RE: 1111 15TH AVENUE EAST, OWEN SOUND – SENIORS RESIDENTIAL BUILDING TRAFFIC OPINION LETTER

The purpose of this letter is to address City staff comments on the proposed access arrangement and review the existing traffic control at the intersection of 15th Avenue East and 14th Street East.

Figure 2: Decision Support Tool – Preliminary Assessment

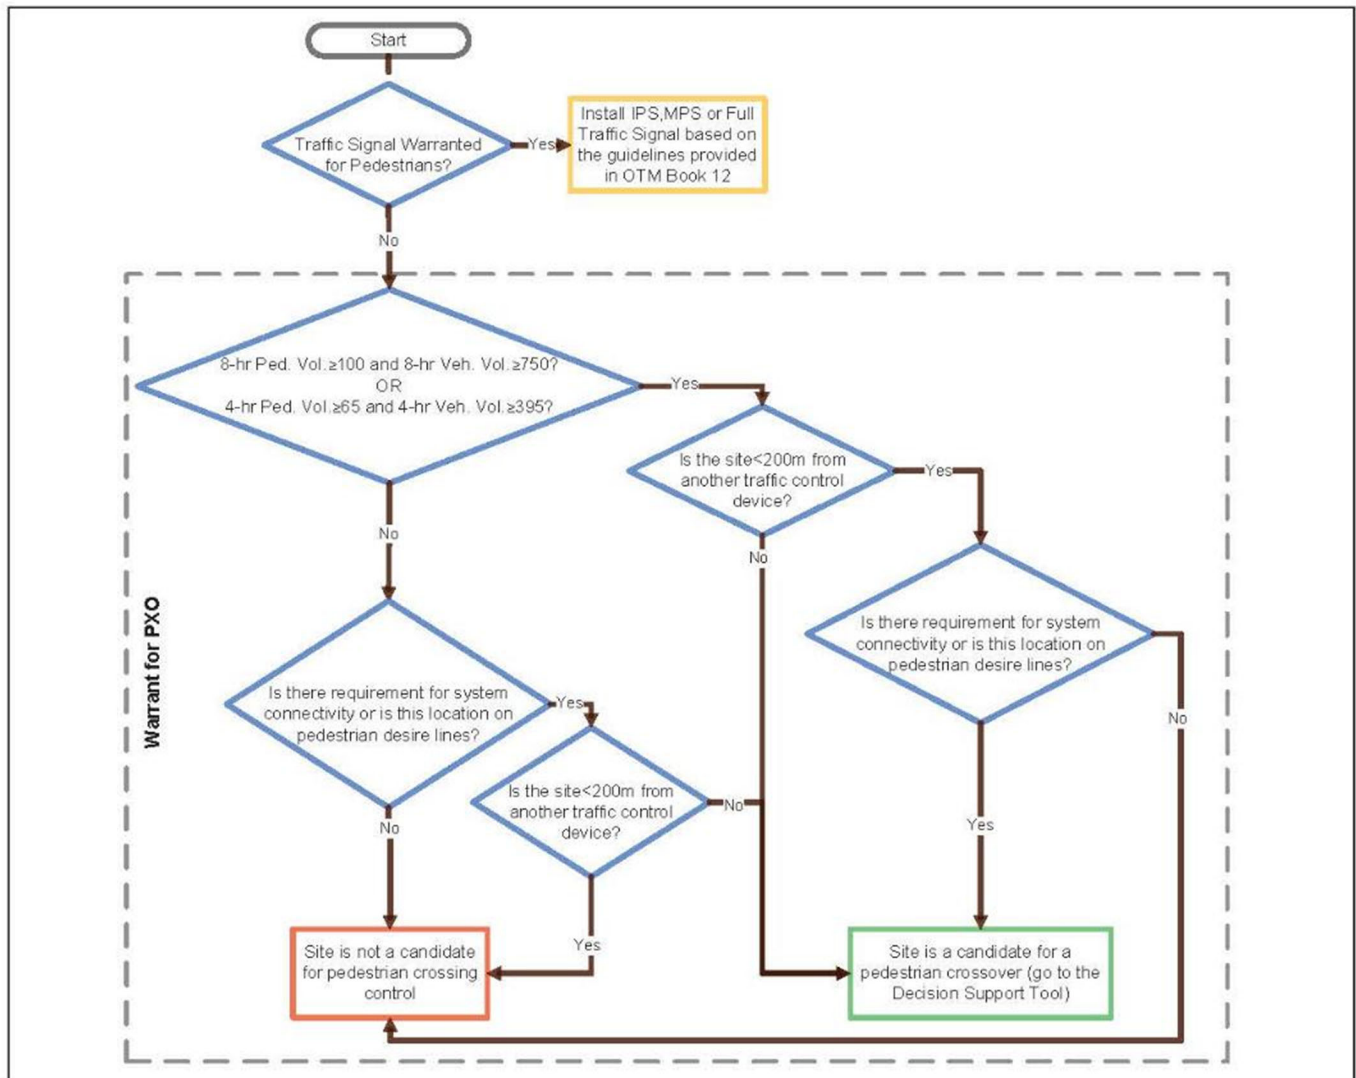
The *OTM Book 15*⁵, which provides recommended practices for the installation of Pedestrian Crossing Treatment Systems for Controlled Pedestrian Crossings, includes a decision support tool (DST) to determine if the location is a candidate for pedestrian crossing control.

The Preliminary Assessment for a PXO begins by assessing a traffic and pedestrian volume where the 8-hour pedestrian volume exceeds 100 and the 8-hour traffic volume exceeds 750, or the 4-hour pedestrian volume exceeds 65 and the 4-hour traffic volume exceeds 395. Based on the forecast traffic volumes in the December 2018 TIS, the traffic volumes on 14th Street East may exceed these thresholds; however, it is not likely that the pedestrian volume thresholds would be met.

The second assessment is for system connectivity or desire lines. As indicated previously, a PXO at this location could facilitate pedestrian movements to/from the multi-use pathway north of 14th Street East. The multi-use pathway connects to the municipal sidewalk along the north side of 14th Street East west of 16th Avenue East, travels along the north side of the stormwater management pond and connects to 14th Avenue East at 15th Street 'B' East. It is our understanding that residents in the area use this trail frequently.

The final assessment reviews if there are other crossings within 200 metres. The closest crossing at a traffic control device is located at 16th Avenue East which is over 200 metres from 15th Avenue East.

Based on the above, the location is considered a candidate for a pedestrian crossing.

Figure 44: Pedestrian Crossover Level 2 Type D – Intersection (2-way)

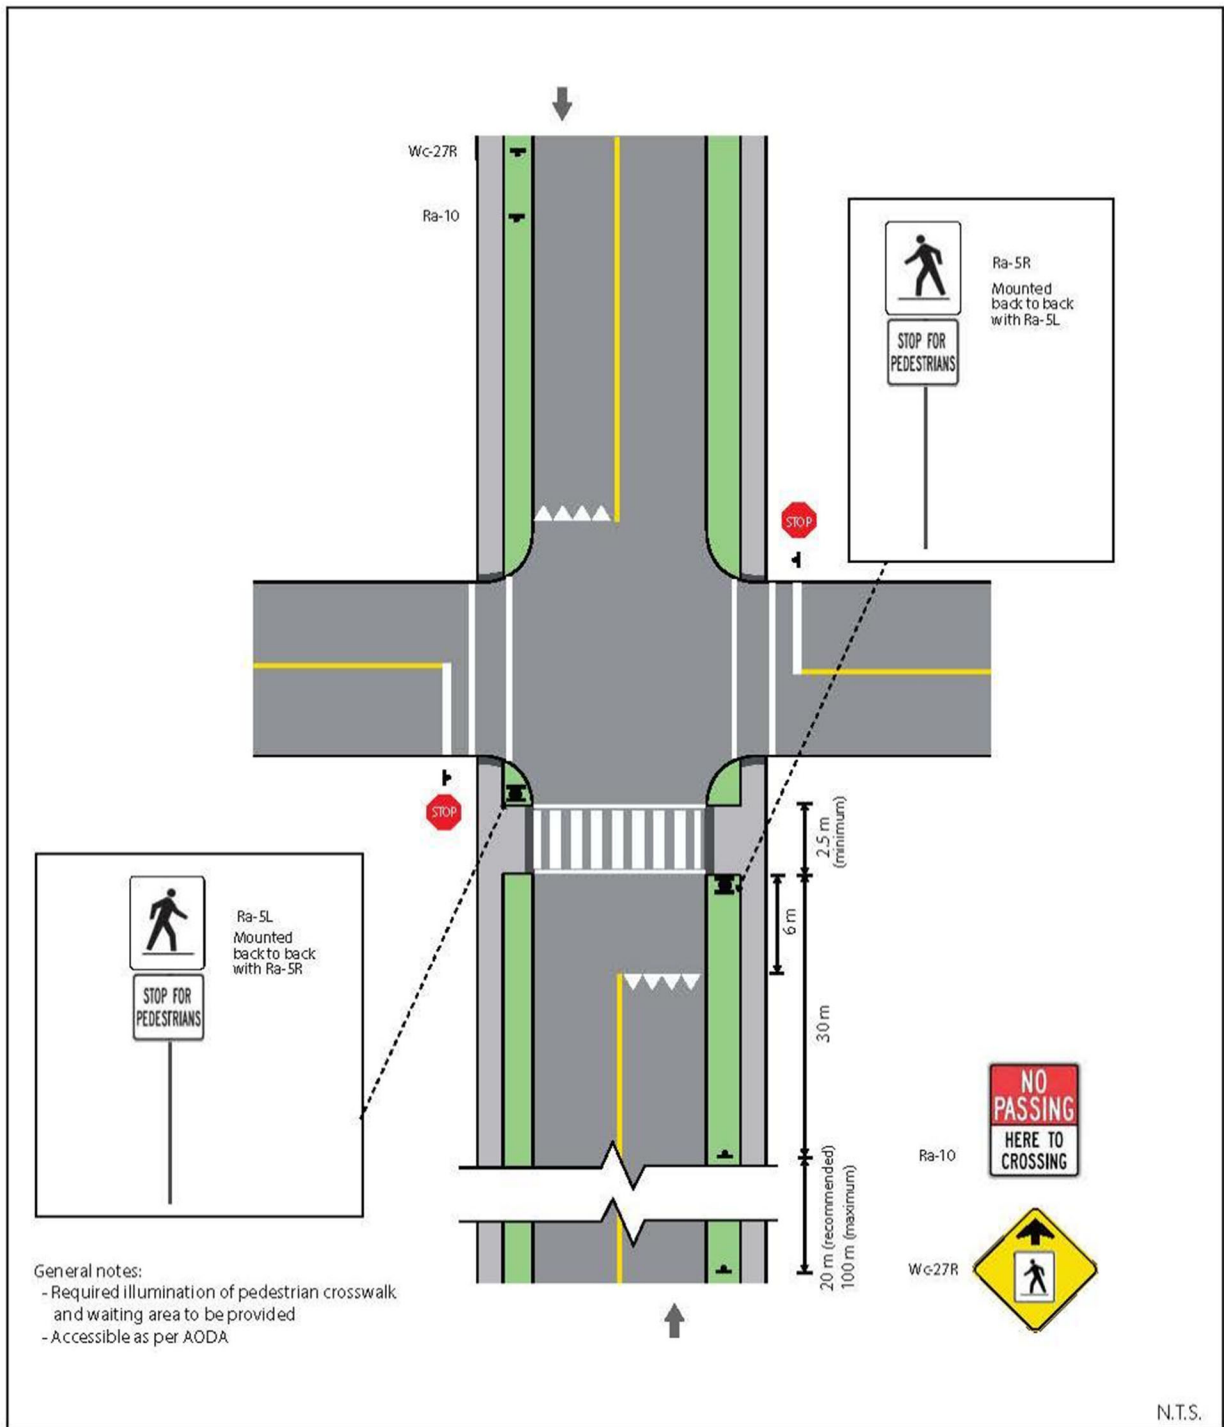
To determine the type of crossing appropriate, the OTM Book 15 provides a selection matrix. Based on the posted speed limit (40 km/h), the two-way vehicular traffic volume from the December 2018 TIS and the number of travel lanes on 14th Street East, a Level 2 Type D PXO could be considered.

To avoid the residential driveway on the north side of the roadway, it is recommended that the PXO be installed to the east of the existing light pole and a new accessible sidewalk connection be provided to the existing municipal sidewalk on the north side of the roadway.
